#### **BUCKINGHAMSHIRE COUNCIL DECISION NOTICE**

Application no. 22/01330/HS2

**Proposal** In accordance with Schedule 17 to the High Speed Rail (London - West Midlands) Act 2017, the nominated undertaker hereby requests approval of PLANS AND SPECIFICATIONS comprising of:

Archaeological Method Statement – Fusion parcel reference numbers C21052P and C21054P

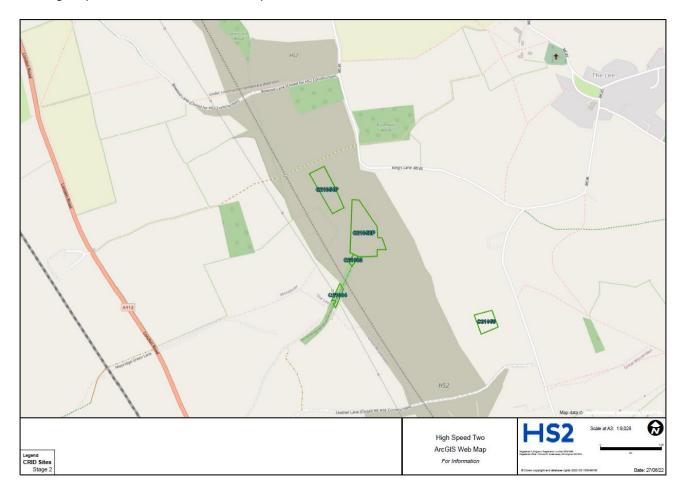
No development or preliminary groundworks of any kind shall take place within Fusion parcel reference numbers C21052P and C21054P until a Method Statement for preservation of archaeological remains has been submitted in writing and approved by the planning authority.

The location of Fusion parcel reference numbers C21052P and C21054P are identified within the High Speed Two ArcGIS Web Map dated 27 June 2022 below.
